D3 CHANNEL BANK
EQUIPMENT INSTALLATION AND TESTS
DIGITAL TRANSMISSION SYSTEMS

1.001 This addendum supplements Section 365-150-501, Issue 4. Place this pink sheet ahead of Page 1 of the section.

Fig. 2—Rear-Bay View of CN6482MV Loop Timing Modification

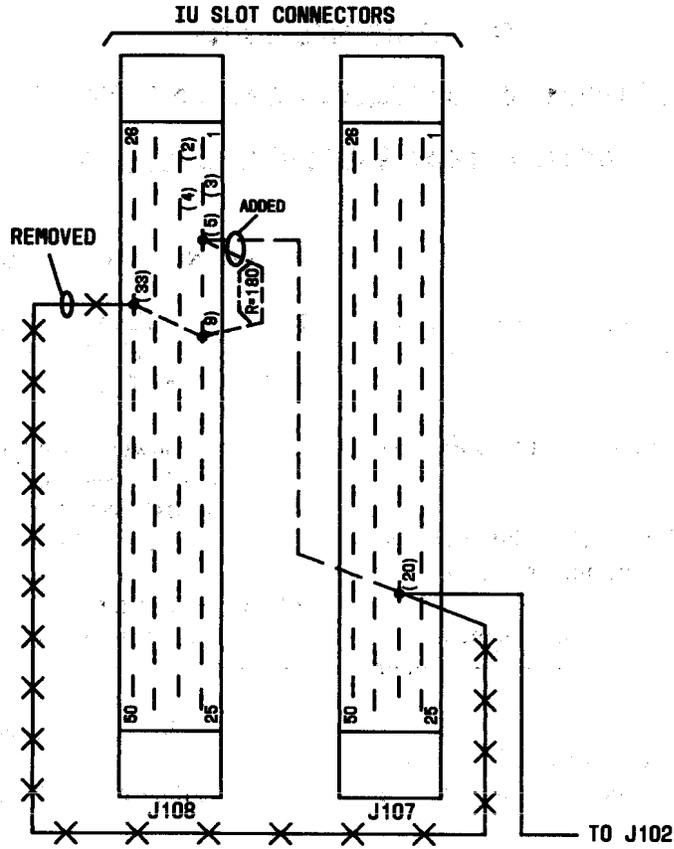
- (a) To include installation of the -48F fuse for the hot spare and maintenance panel
- (b) To change the +4 or +4.2 volt requirement for the J87380B PCU to allow a higher output with no load
- (c) To correct the location of terminal 20 in Fig. 2 which shows the modification for loop timing.

2.003 On Page 25, change Fig. 2 according to the figure on the back of this sheet to show the correct location of terminal 20.
